**M2003-001 Nissen TR3
Adequacy Response 1**

Nissen Farm Resource

Permit M2003-001

BURNCO Colorado LLC (BURNCO) is submitting this Technical Revision (TR3) to propose changes to the Nissen Farm Resource Mine Plan Map, the Reclamation Plan Map, and to provide updated calculations for the reclamation cost estimate. The following changes are being proposed:

Mining Plan

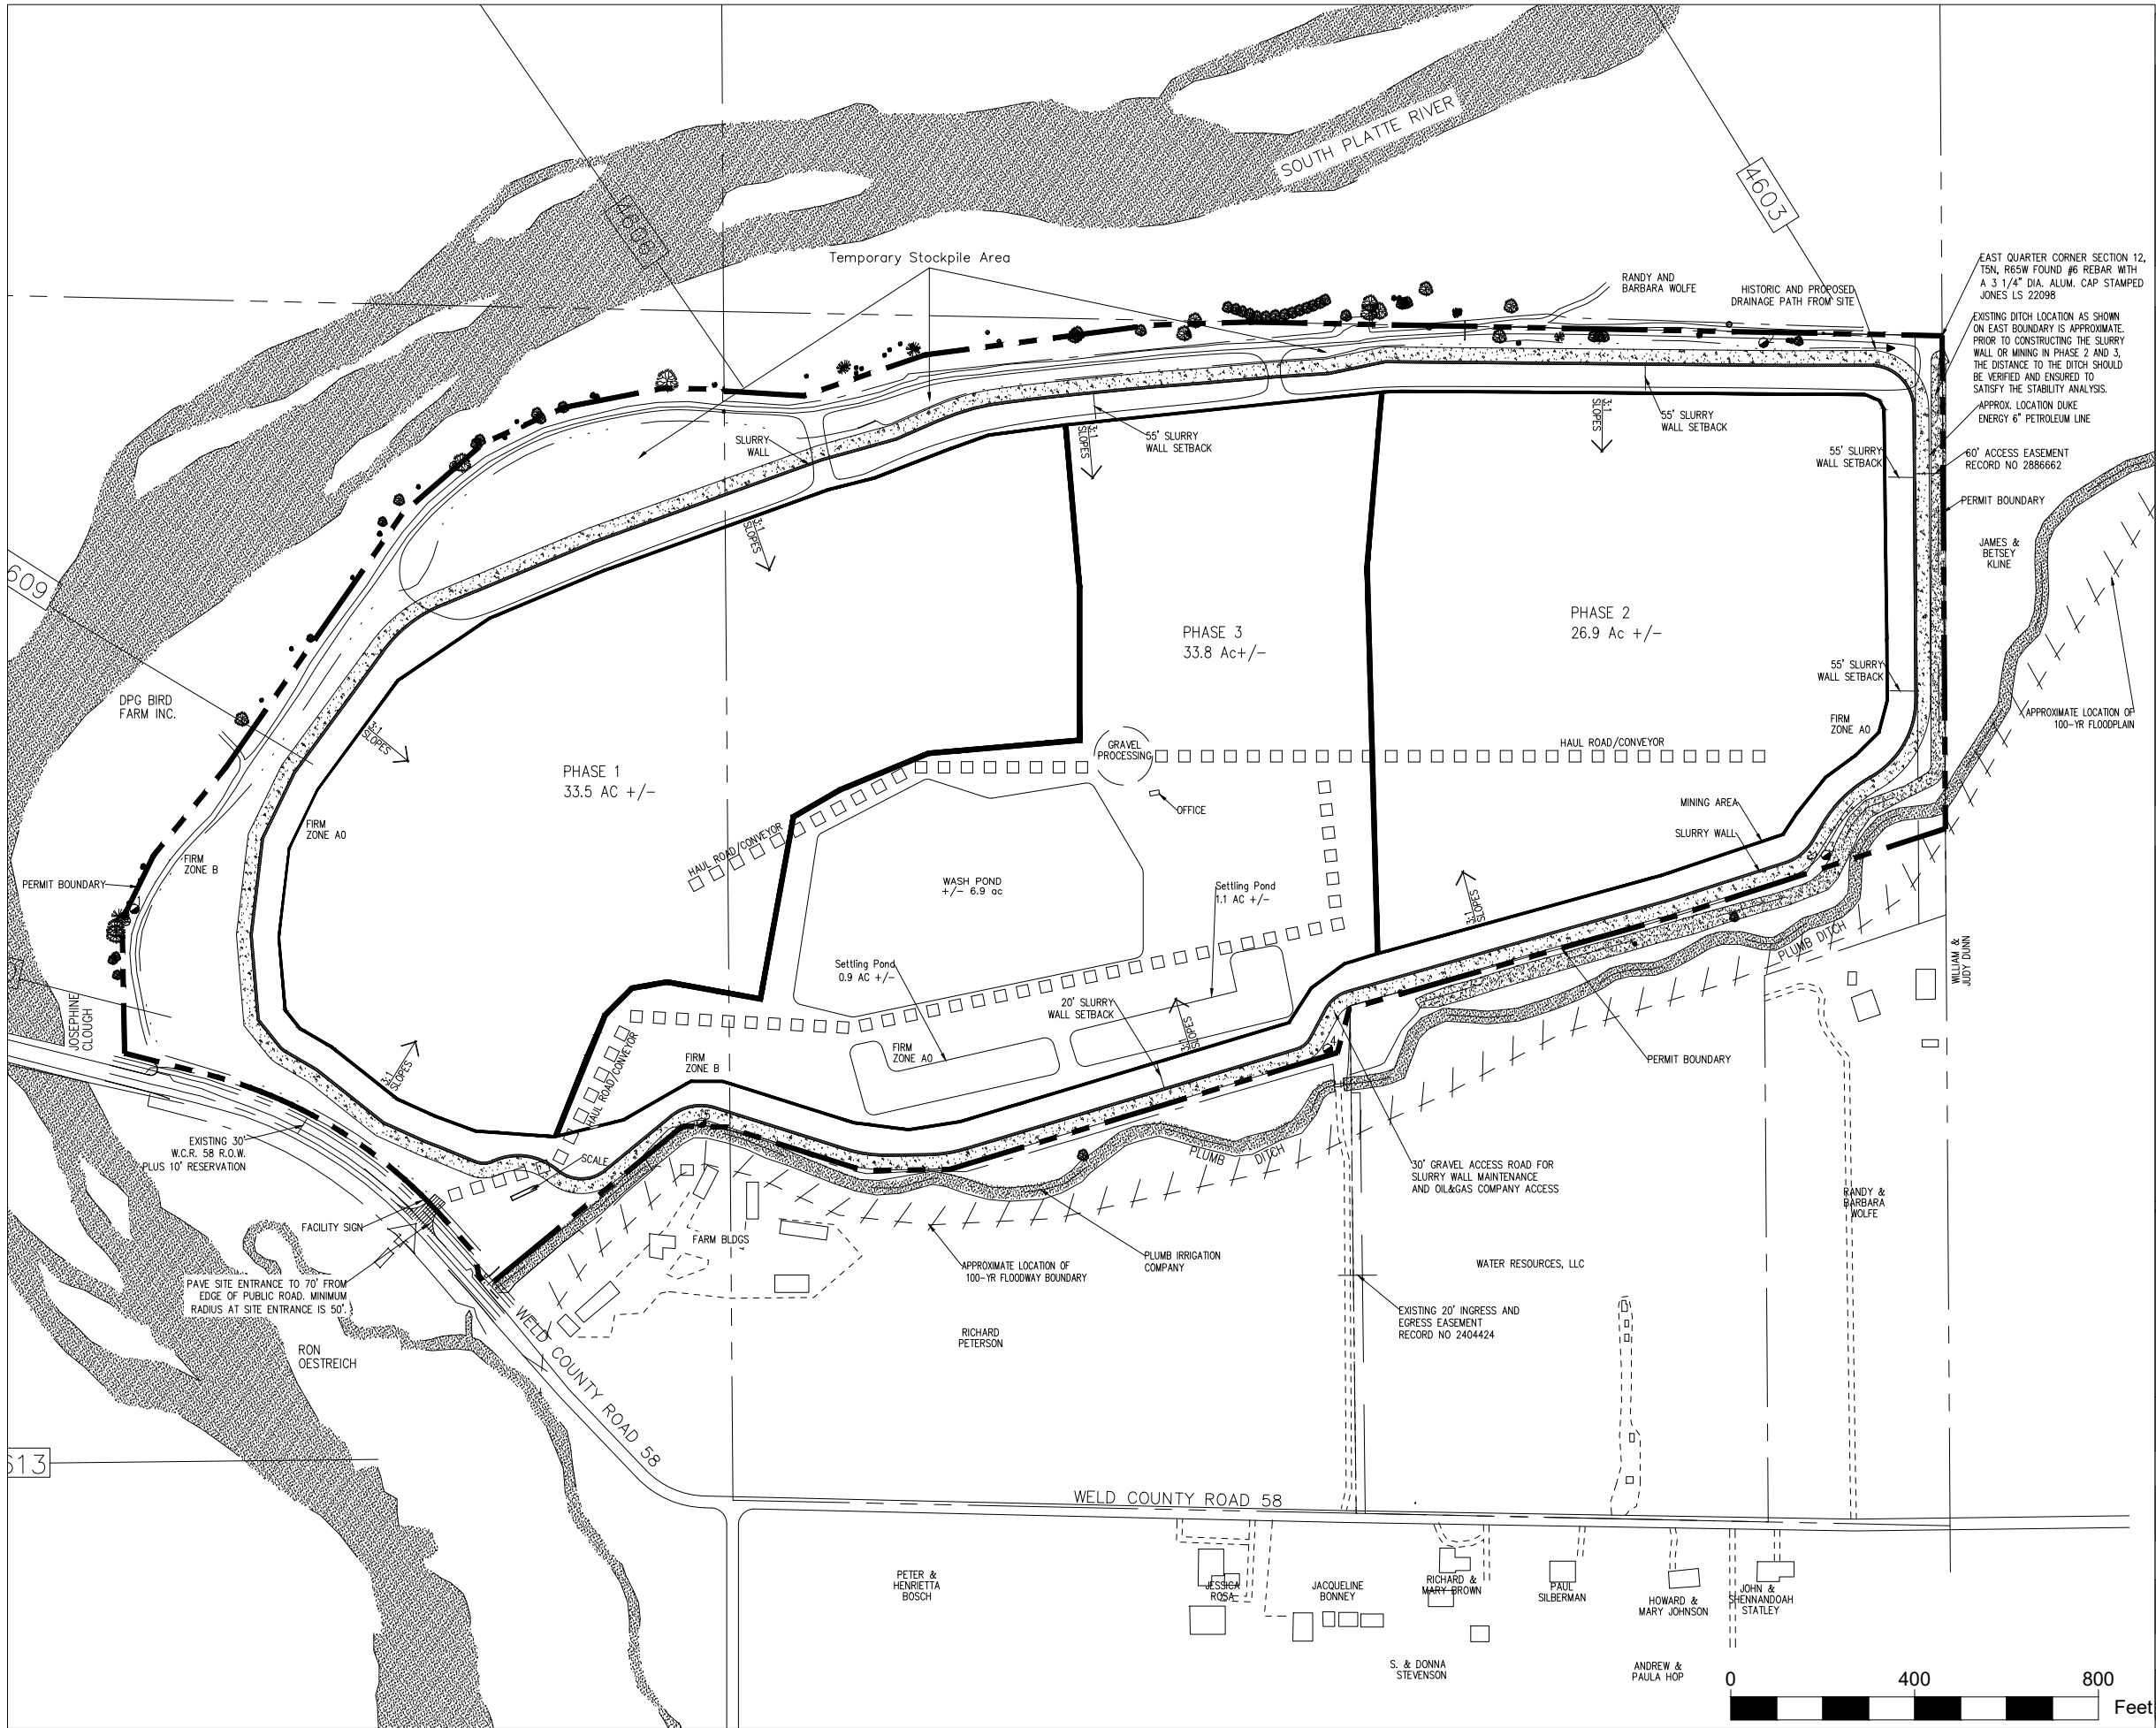
a. All updated mining and reclamation plan maps must comply with the requirements for exhibits in Rule 6.2.1(2). Neither of the maps provided have a map scale, or signatures of the qualified person that prepared them. Please update as needed.

b. Both Mining and Reclamation Plan maps are required to show existing (mining) and proposed (reclamation) topography sufficient to show elevations, direction, and slopes of the affected land. Please add this information to the provided maps, or submit additional maps to show this data.

c. Please update both maps to reflect the current FEMA flood hazard designations for the site.

f. What is the feature on the east side of both maps outlined with the “%” symbol? Please add this to the legend or remove from the maps as appropriate.

Added map scales and signatures to each map.

Added additional map including all existing mining contours and proposed reclamation contours.

Updated maps to reflect the current floodplain.

Removed % feature from maps.

Updated
Reclamation
Plan

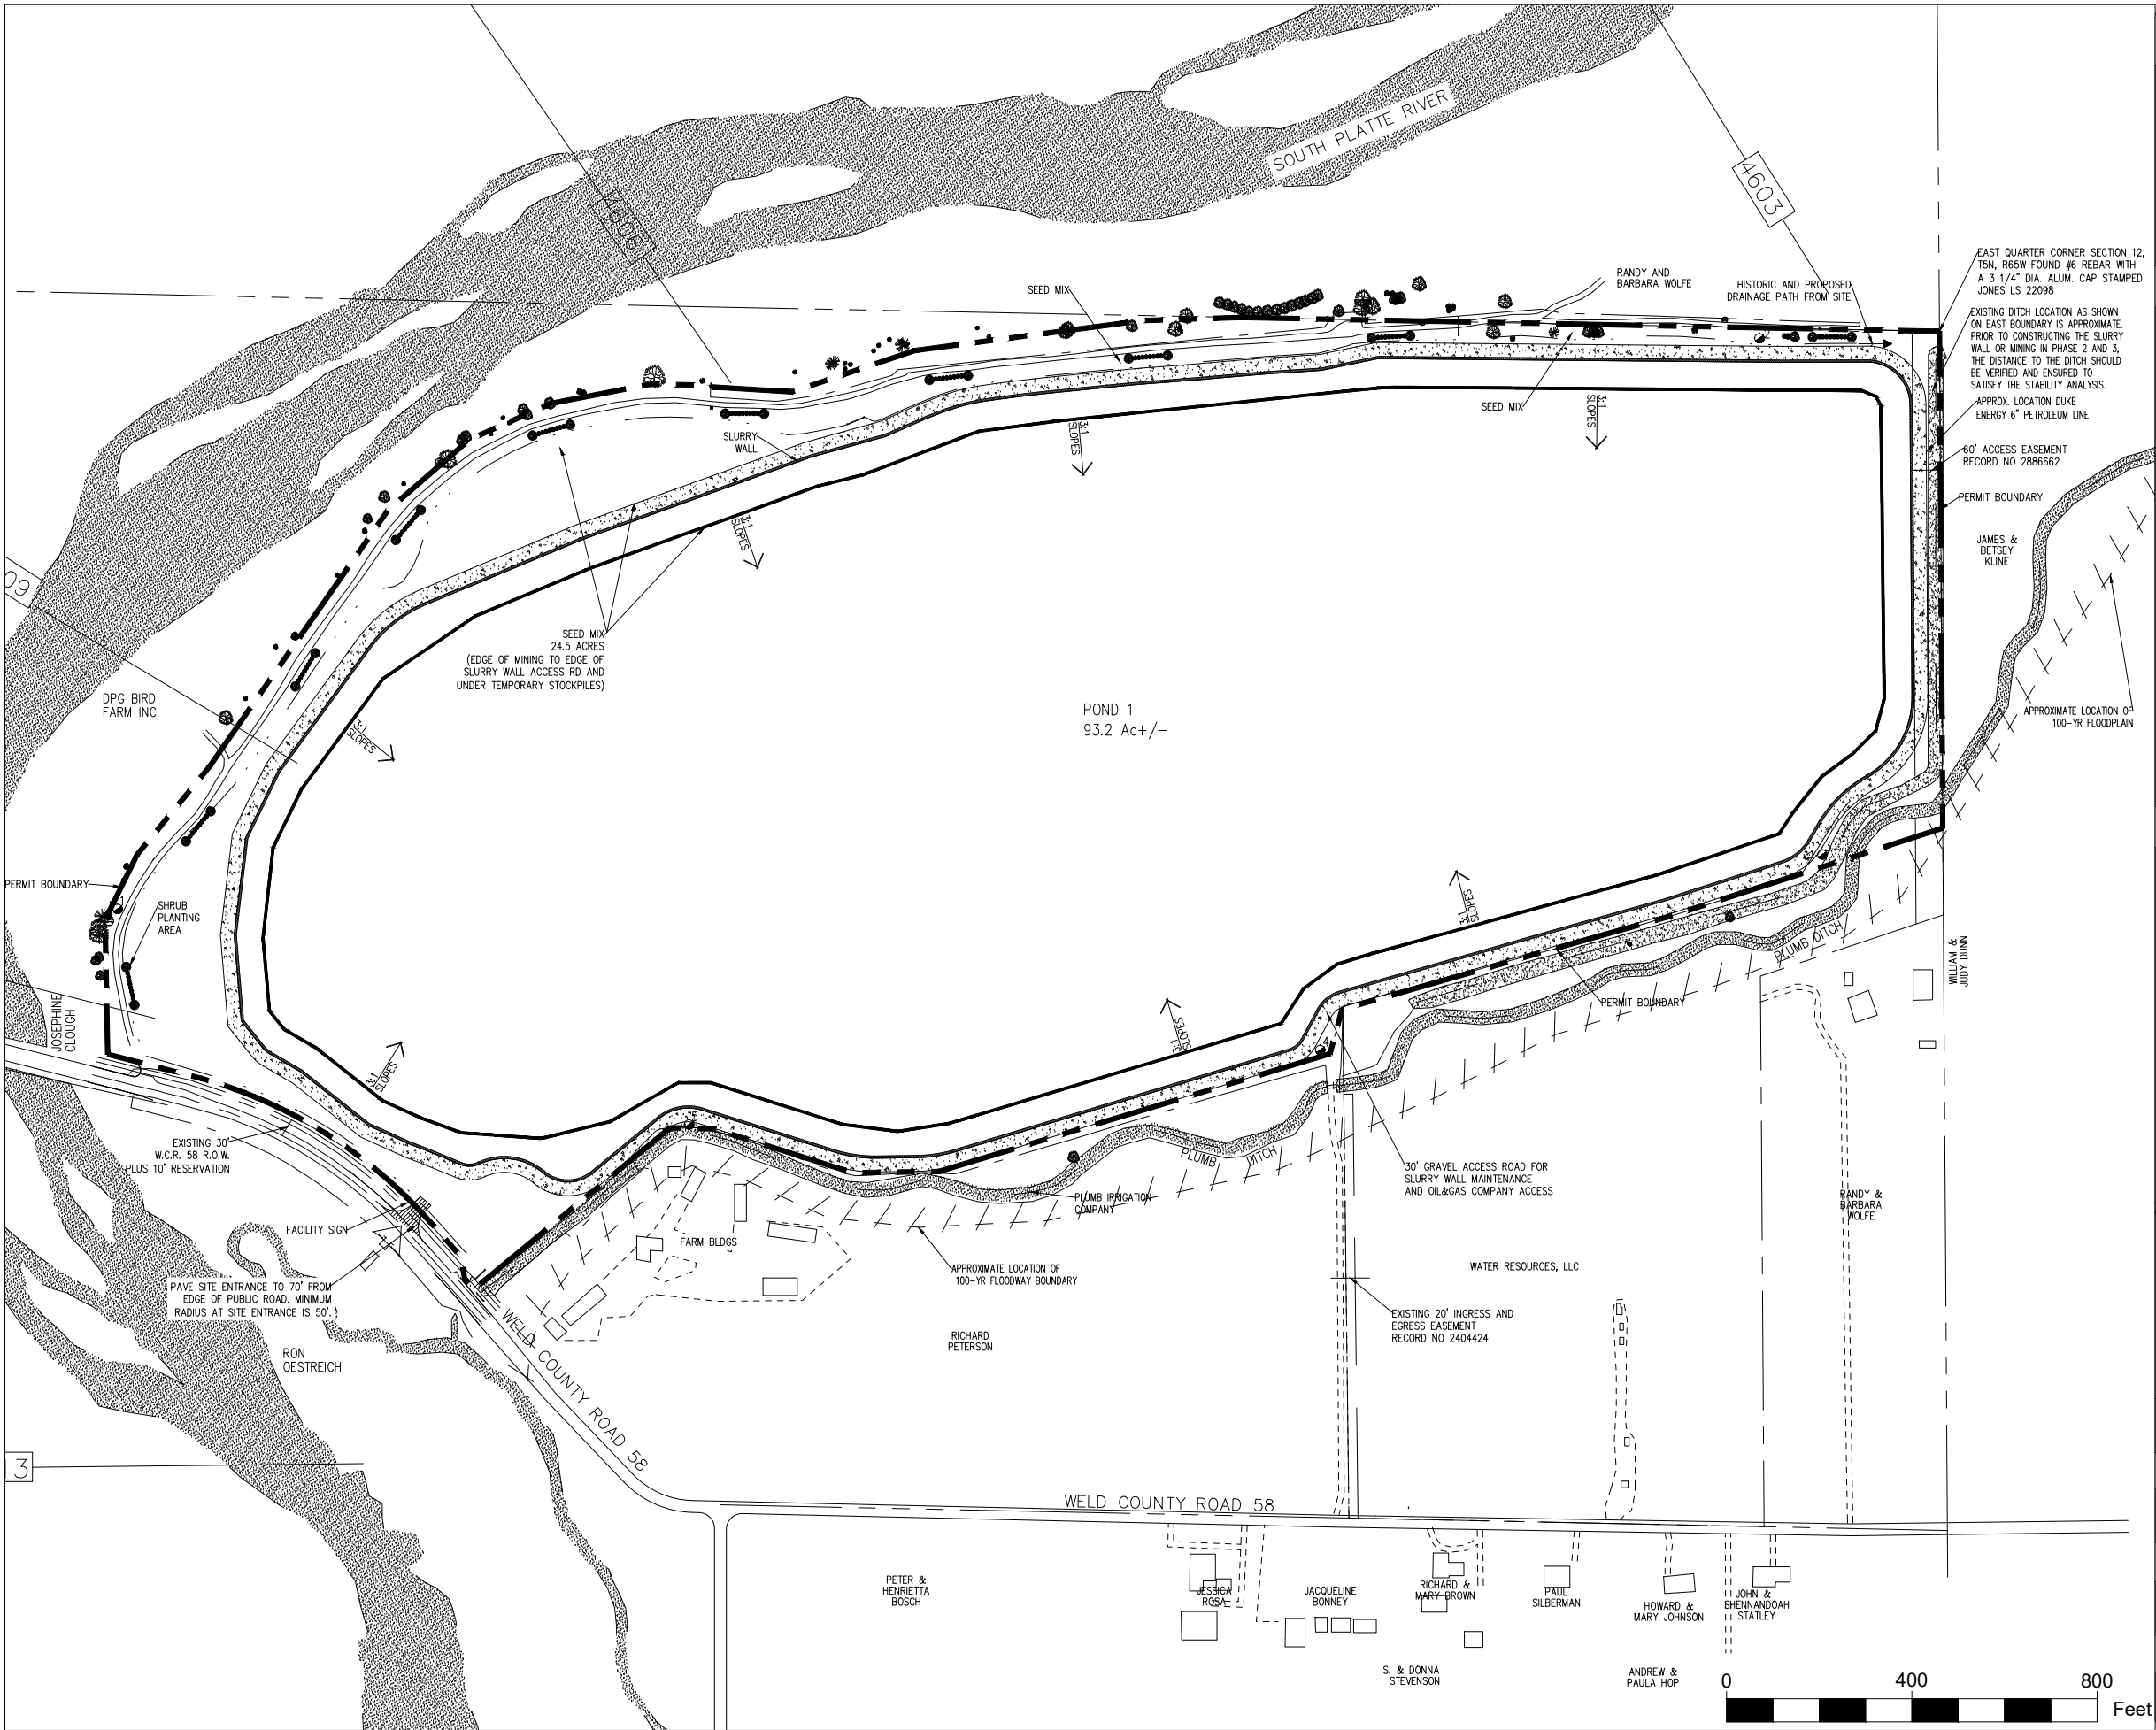
d. The current reclamation plan does not contemplate exposed groundwater or a permanent augmentation plan for the wetlands area currently shown on the updated mining and reclamation plan maps. The only water body will be the lined reservoir. The wetland area on the provided maps is shown where settling pond was originally planned, but is now under a large stockpile. Please remove the wetland area from the maps, or provide sufficient detail in the reclamation plan as to how the wetland will be created and how the resulting groundwater exposure permanently augmented to comply with SEO requirements.

e. The notes provided for the maps which contain the reclamation seed mixes denote four different seed mix types: upland, pond area, wetland, and upland for tree/shrub (210 shrubs and 20 trees). Please show on the reclamation map TR3 Adequacy Review 1 Nissan Farm Resource (Permit M2003-001) Page 3 of 3 the areas/acreages where these mixes will be used. You will also need to specify the numbers and size (1 gallon, 3 gallon etc.) of trees/shrubs of each type per acre to be planted and show approximate tree shrub planting areas on the reclamation plan map. Please note that planting trees/shrubs too close to a lined reservoir may jeopardize the integrity of the liner if it is impacted by root growth.

Removed wetland area from maps.

Removed pond area and wetland seeding from the tables. Upland area seed mix and planting requirements remain. Added notes to map showing area and acreage where seeding will take place and location of shrub planting. Shrub planting was originally all inside of the slurry walls on sections that are removed. Included new reduced shrub planting along the north edge of the property where space remains to protect the slurry wall.
